Pavement Preservation and Rehabilitation Program

2019 Overlays and Curb Ramps Project

Bid #3080

Addendum #1

Drawing No. **TS3**
 Sheet No. 17 of 58

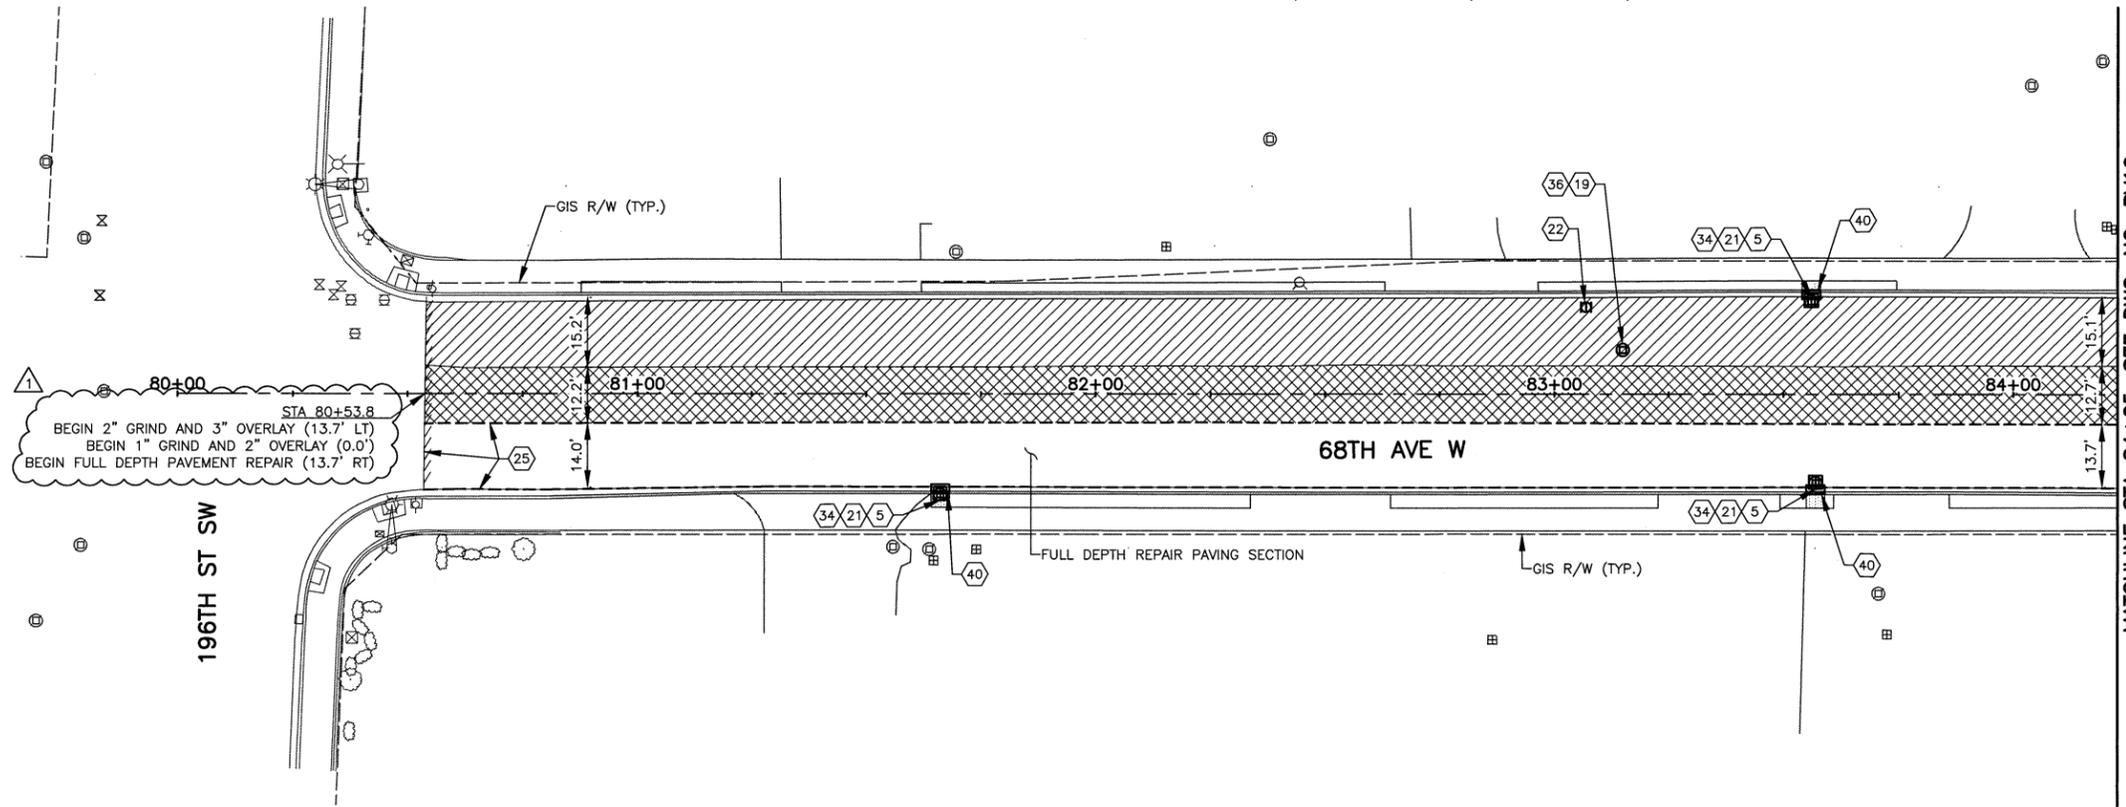
- A. Sheet 17 (TS 3) – the crushed surfacing top course layer depths, construction note 3, on all of the Typical Roadway Sections on Sheet 17 are REVISED to reflect 3 inches depth. The pavement depth of the final overlay (Construction note 1) on the Typical Roadway Section – Site 3 Section, and the Alternate Edge Grind and Overlay Section is REVISED to reflect 3 inches HMA overlay at 2 inch grind locations. Asphalt Taper to Existing Gutter detail added to Sheet 17.

- Replace in its entirety with the revised sheet, sheet 17, which is included as an attachment to this addendum.
- B. Sheets 18-23 (PV9-PV14) -- The diagonal hatching in the legend is REVISED to read 2" Grind and 3" Overlay per Detail, DWG. No. TS3. The cross hatching in the legend is REVISED to read 1" Grind and 2" Overlay per Detail, DWG. No. TS3.

Drawing No. **PV10**
Sheet No. 19 of 58

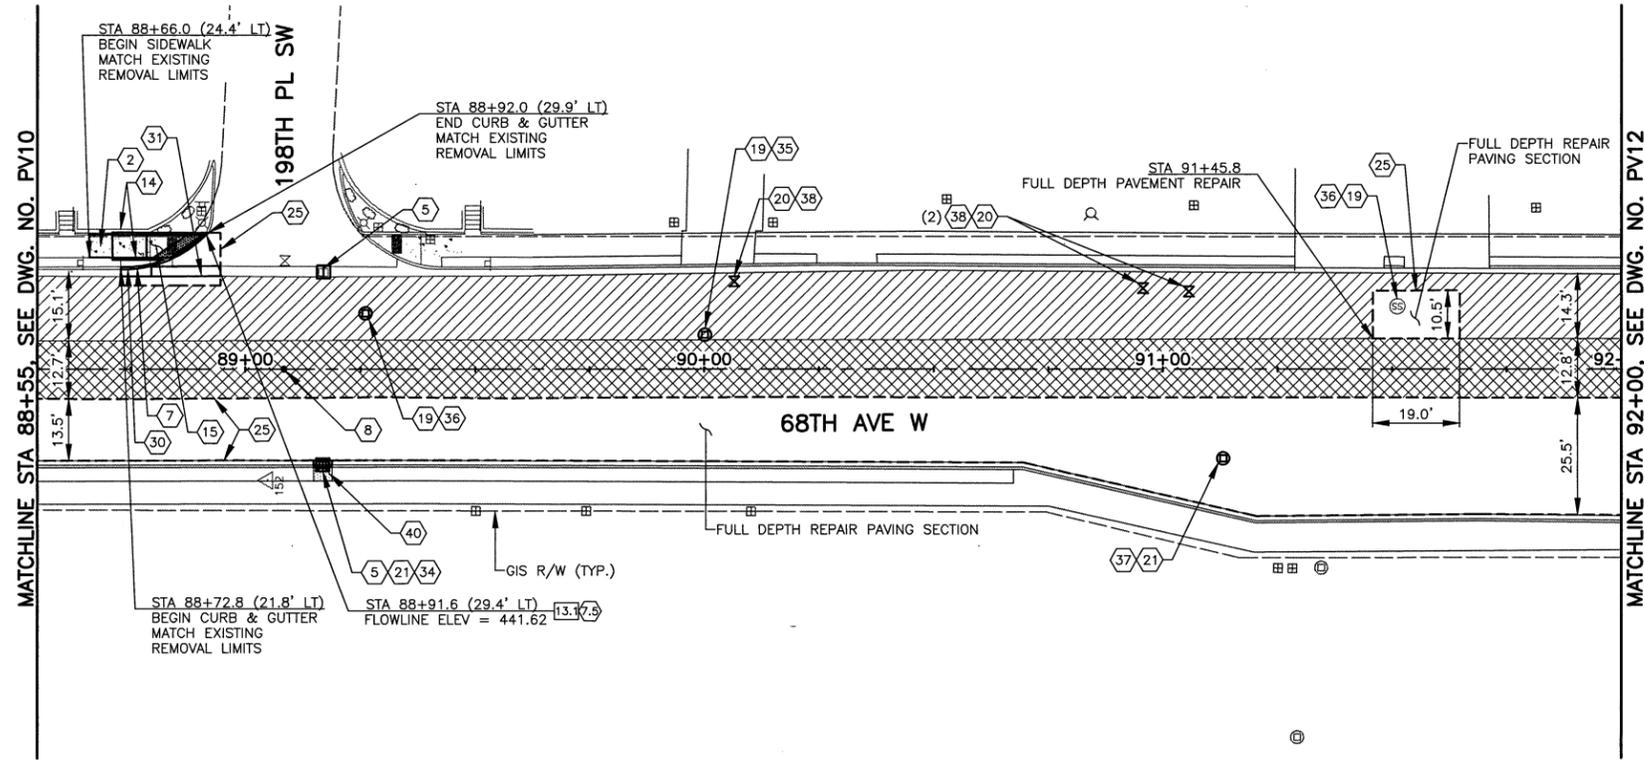
- Replace in their entirety with the revised sheets, sheets 18-23, which are included as an attachment to this addendum
- C. Sheet 19 (PV10) – the "Pedestrian Crossing Section A-A" detail is REVISED to reflect 3 inches of CSTC under the HMA paving adjacent to the new raised pedestrian island. The "Pedestrian Crossing Detail" was REVISED to correct the offset of two angle points detailing the location of sawcuts.

- Replace in its entirety with the revised sheet, sheet 19, which is included as an attachment to this addendum.
